CERTIFICATE OF APPROPRIATENESS PLACARD

324 CUTLER STREET

083-14-MW

- Alterations to existing garage:
- replace garage door,
- replace metal roof;
- construct low retaining wall

Existing Garage:

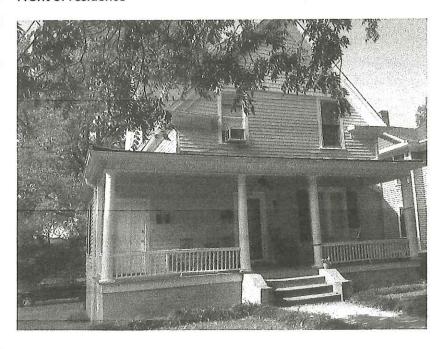
- What are the dimensions of the existing garage door opening/front of the garage? I need a better idea of how the new door will be fitting into the existing garage.
- Per our telephone conversation you are changing the rear section of fence to also be a wood picket style. (Per Guideline 2.4.10 chain link fence is prohibited)
- Also per our telephone conversation, I am moving the fence request to the Major Work application submitted since as staff I can only approve fences up to 42" in height.

The existing garage has two doors that are 7ft tall and 7.5 feet wide

Here is a mock up of the new door. I did not replicate the board and batten siding all the way across on the drawing to make it easier to see.
